Model: RDH for F401/411/421		Date: 15-Jun-97	No: 1
Modified Article: Sensor Seal		Prepared by: M.Kitajima	
From: QAC 1st Field Information Dept.			
Reason for Modification:	<input type="checkbox"/> Parts catalog correction	<input type="checkbox"/> Vendor change	<input type="checkbox"/> To meet standards
	<input type="checkbox"/> To facilitate assembly	<input checked="" type="checkbox"/> To improve reliability	()
	<input type="checkbox"/> Part standardization	<input type="checkbox"/> Other

Model: RDH for F401/411/421/Cardinal		Date: 31-Aug-97	No: 2
Modified Article: Parts Catalog		Prepared by: H.K	
From: QAC 1st Field Information Dept.			
Reason for Modification:	<input checked="" type="checkbox"/> Parts catalog correction	<input type="checkbox"/> Vendor change	<input type="checkbox"/> To meet standards
	<input type="checkbox"/> To facilitate assembly	<input type="checkbox"/> To improve reliability	()
	<input type="checkbox"/> Part standardization	<input type="checkbox"/> Other

Model: RDH for F401/411/421/Cardinal		Date: 31-Dec-97	No: 3
Modified Article: Parts Catalog		Prepared by: H.K.	
From: QAC Field Information Dept.			
Reason for Modification:	<input checked="" type="checkbox

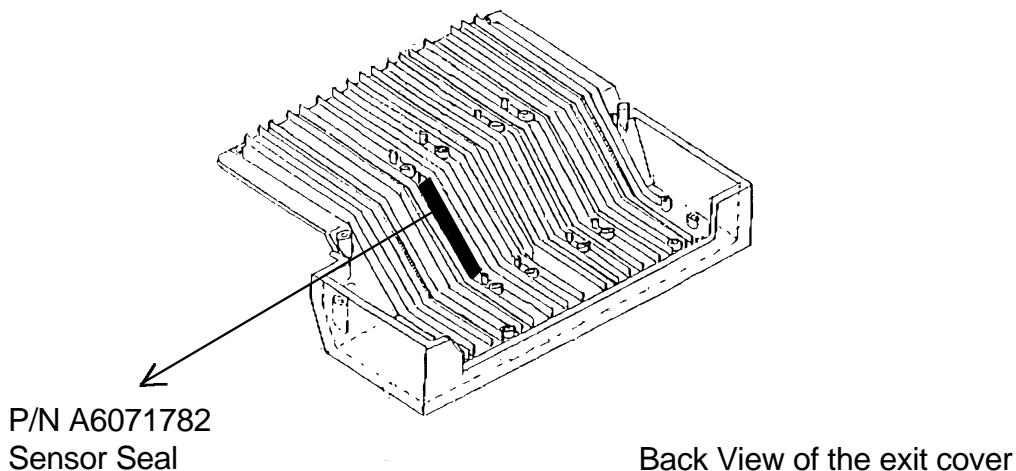
To prevent the exit sensor from mis-detecting, a sensor seal has been added on the back side of the exit cover.

Old part number	New part number	Description	Qty	Int	Page	Index	Note
	A6071782	Sensor Seal	0→1	—	19	*28

Figure No.1

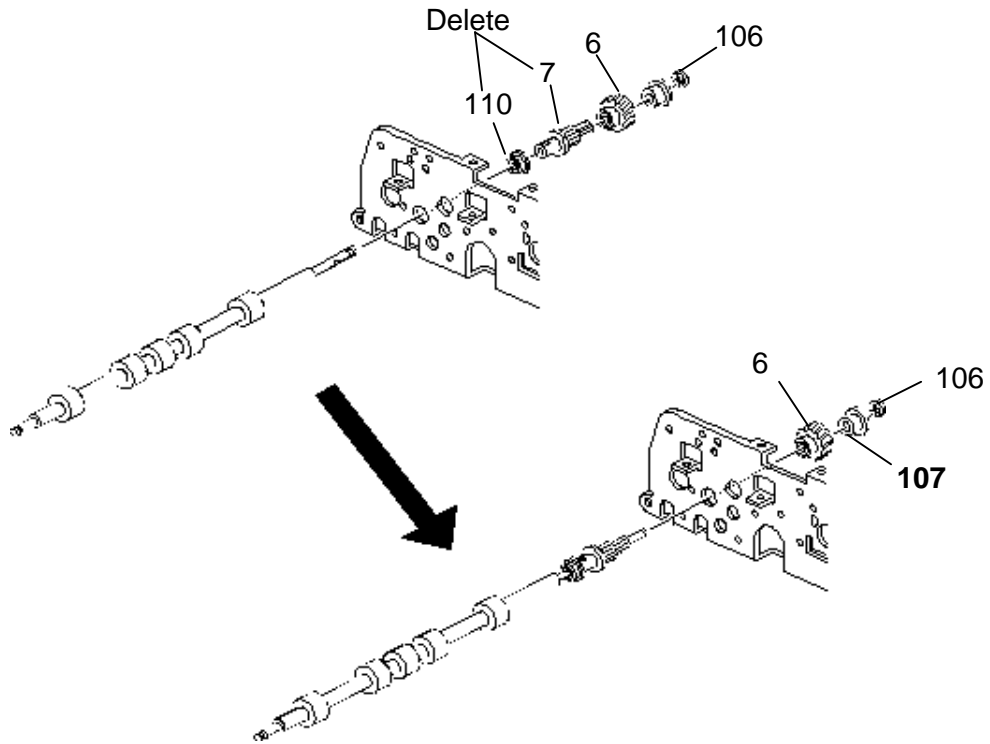
The parts for Index 7 and 110 on page 6 are press-fitted to the feed out roller (A6071099). For illustration correction, please correct your parts catalog on page 6 as follows and delete the following part number from your part catalog (figure No.1).

Parts Number	Description	Index No.	Page
A6071092	Gear – 20Z	7	7

Figure No.2

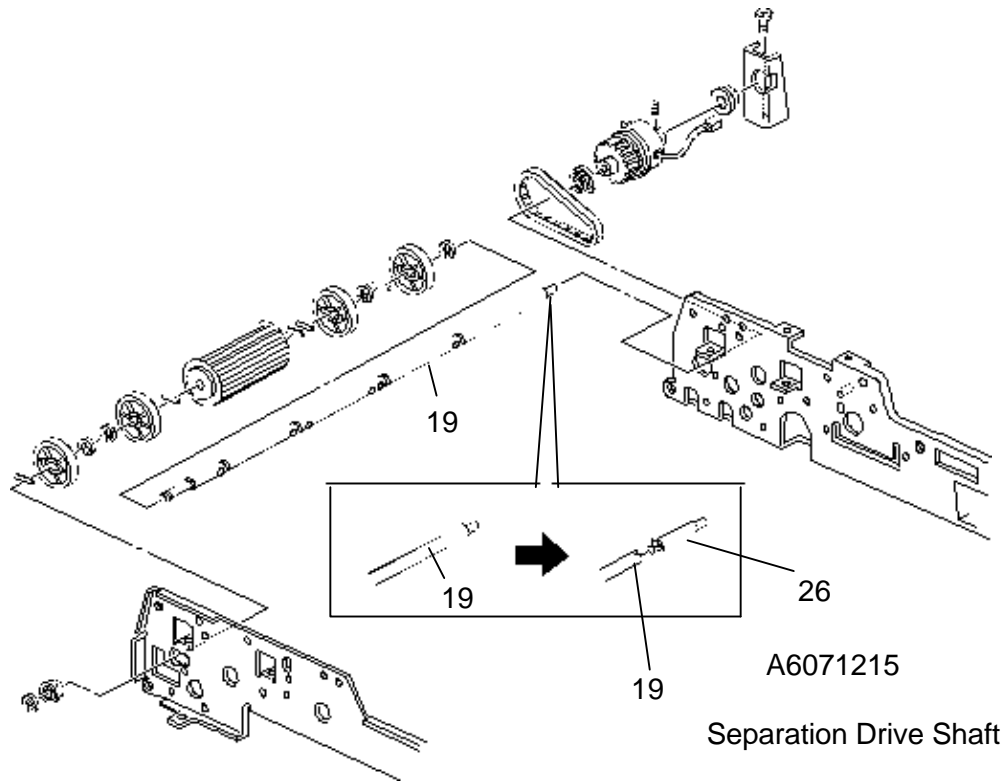
Please add the following part number to your parts catalog (figure no.2).

New P/N	Description	Quantity	Index No.	Page
A6071215	Separation Drive Shaft	1	26	7

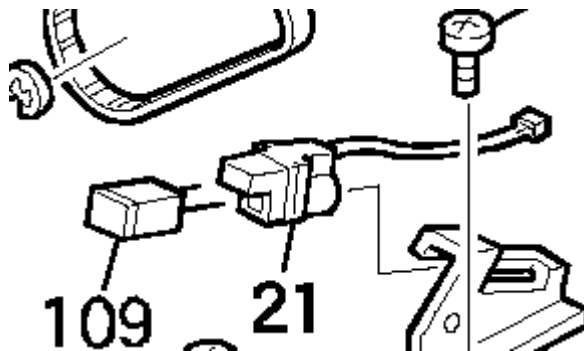
Please correct your parts catalog as follows:

Incorrect P/N	Correct P/N	Description	Quantity	Index No.	Page
11050192	14030493	LED - Green	1 - 1	109	25

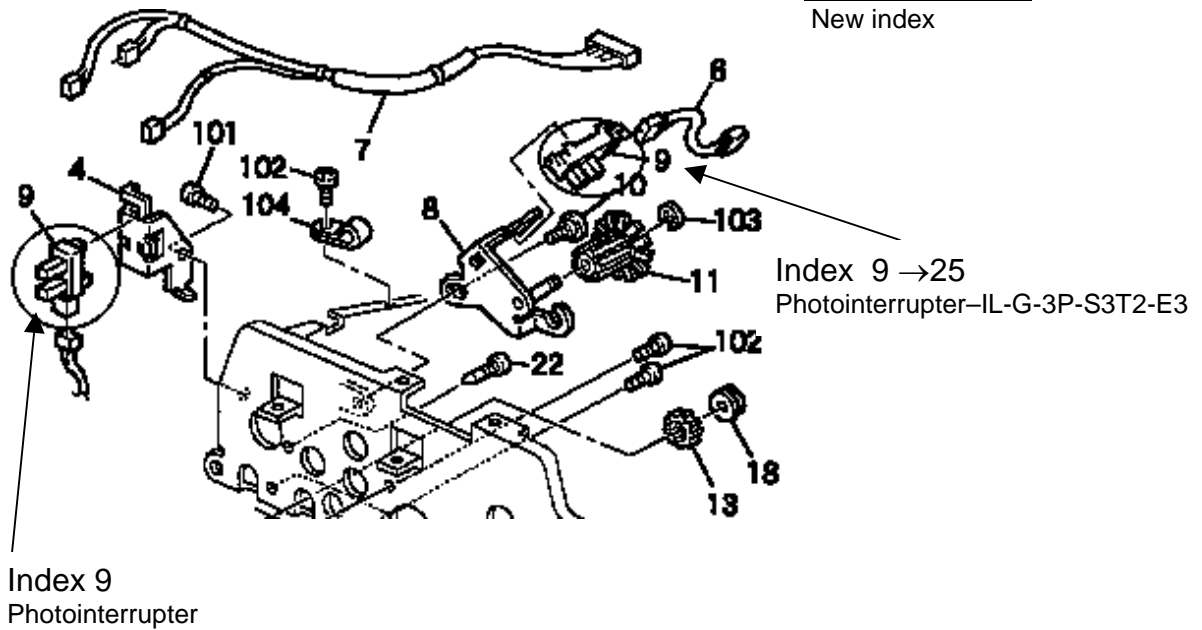
Please apply the following parts number and index number corrections to your parts catalog.

P/N	Description	Q'ty	Page	Index
Incorrect	AW020075	Photointerrupter	2	11	9
Correct	AW020075	Photointerrupter	1	11	9
	52165245	Photointerrupter-IL-G-3P-S3T2-E3	1	11	*25
